DIGITAL	FCO	CATEGORY [F]	PAGE 1 OF 5
FIELD CHANGE ORDER		NUMBER: PC736-F001, PC741-F001 PC743-F001, PC744-F001, PC746-F001

APPLICABILITY: This "F" coded FCO should be installed on DECpc736, 741, 743, 744 and 746 computers at customer sites that require the BIOS support for 5.25", 360KB formatted diskettes. It will upgrade the PCs by replacing the BIOS ROM with revision level 1.22 on the Main Logic Board, P/N 54-22042-01.

Field Installation and verification Procedure for BIOS V1.22

Figure 1: Main Logic Board layout

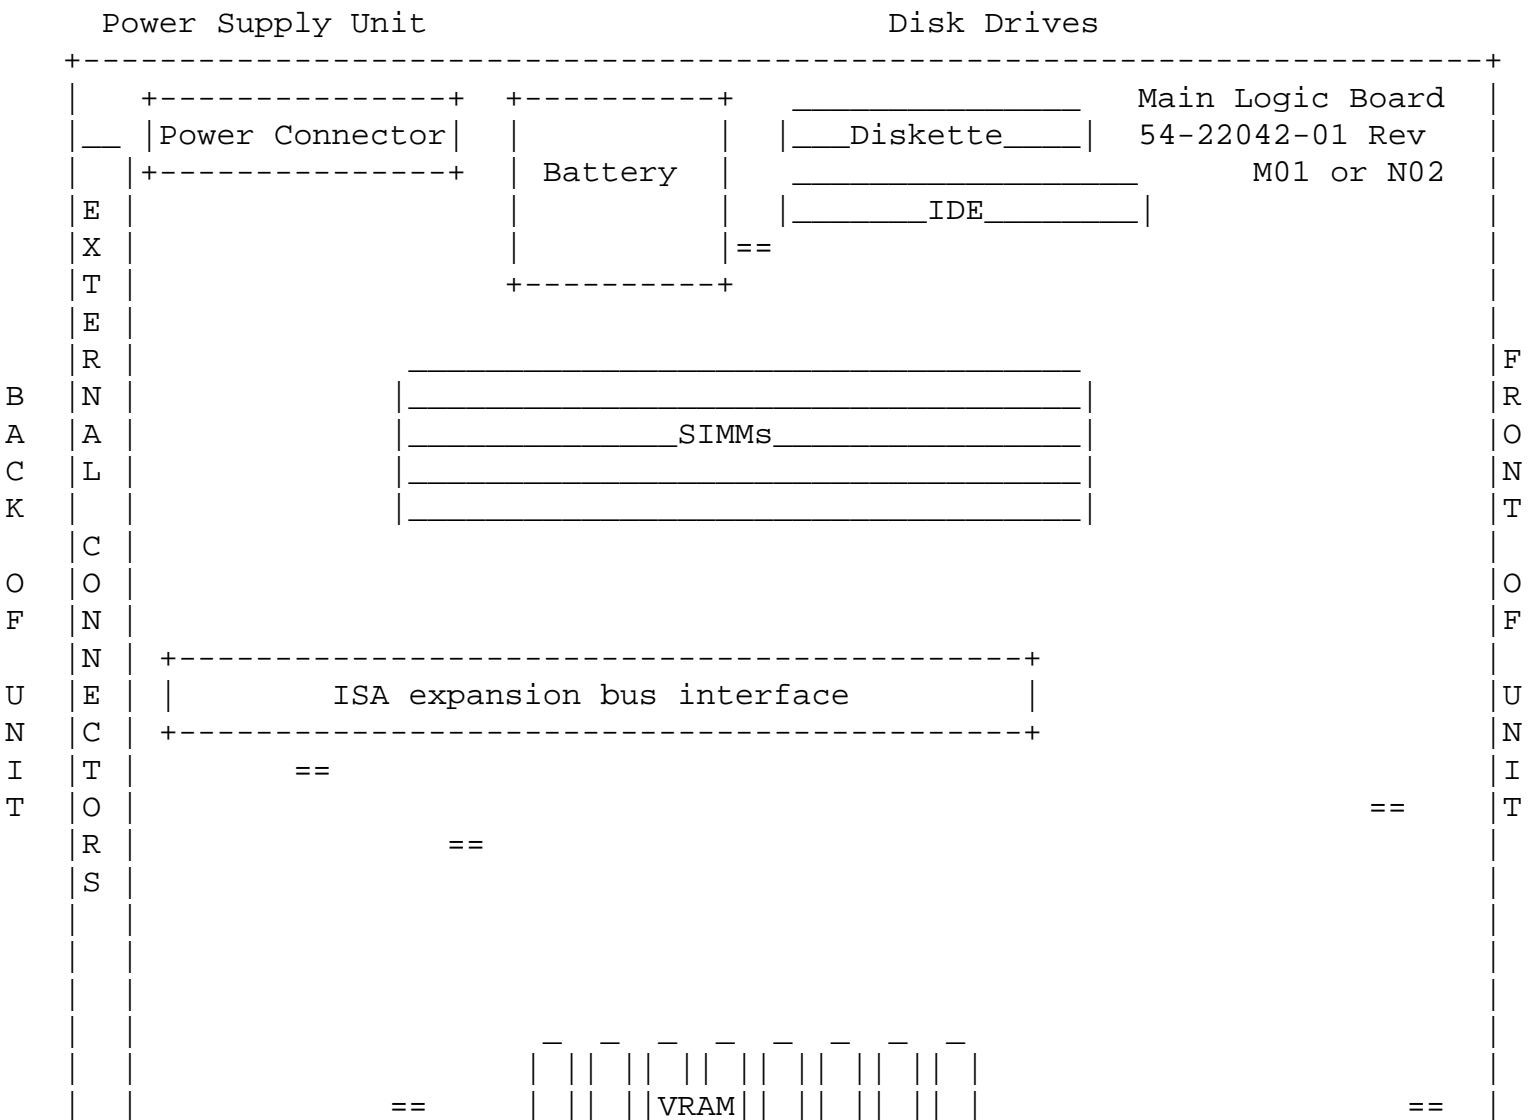
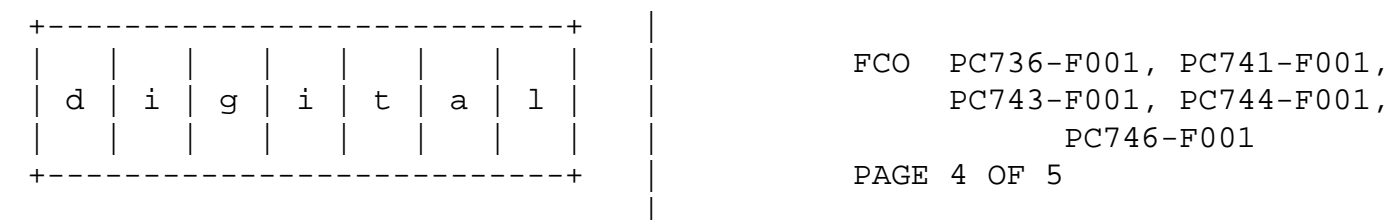
6. Locate the BIOS ROM on the Main Logic Board. Refer to the following diagram for visual assistance: (The BIOS ROM is located on the left side of the Main Logic Board.)

- Use the chip extracting tool to remove the old BIOS ROM, pay attention to the chip orientation and make a note of which way the notch is facing. Replace it with the BIOS ROM V1.22 (23-397E9-00) supplied in EQ-01671-01. Pay particular attention to pin alignment and chip orientation when you are replacing the BIOS ROM. The notch on the ROM should face the back of the chassis, refer to Figure 1 on previous page for visual assistance. The notch on the chip is indicated by ">". Check to make sure there aren't any bent pins after you've replaced the chip.

SOLUTION: Replace the BIOS ROM in location E48 on the Main Logic Board 54-22042-01 with BIOS ROM, P/N 23-397E9-00 (BIOS V1.22).
